SERVICE PARTS LIST

BULLETIN NO.
54-40-0182

SPECIFY CATALOG NO. AND SERIAL NO. WHEN ORDERING PARTS		REVISED BULLETIN 54-40-0181	DATE Feb. 2013
O.E.M. SAW MOTOR			
CATALOG NO.	6465	STARTING SERIAL NUMBER	772B
		WIRING INSTRUCTION 58-01-0751

23-66-1800, 23-66-2090 ON-OFF 'PANEL SAW MOTOR' SWITCH REPLACEMENT OPTIONS

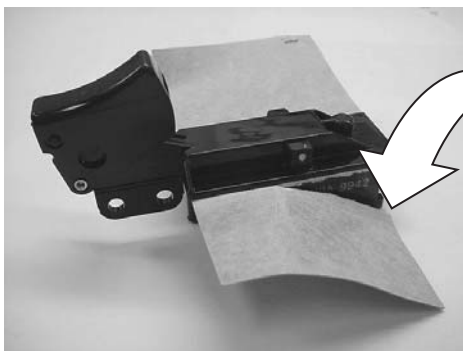
23-66-1800, 23-66-2090 Panel Saw Motor ON-OFF Switch for 6410, 6411, 6465 & 6466 Panel Saw Motor is obsolete - no longer available; it can be replaced by one of two options...

Option 2 - 23-66-0250 ON-OFF Switch (including four [4] 5-40 x 1/4" US SAE switch screws) with 'lock-on' button and without Padlock - Lock-Out hole (switch lock-out feature) is identical to the 23-66-1800 or 23-66-2090 in rated amp capacity and wiring however, use of this switch requires trimming off the (grey) paper from the switch body - directly at the switch body, a minor modification, see photo. Note: original Metric screws from 23-66-2090 should not be used in 23-66-0250 Switch; use only the four [4] 5-40 x 1/4" US SAE switch screws supplied with the 23-66-0250 Switch.

trim/cut off switch insulator
from both side of switch body
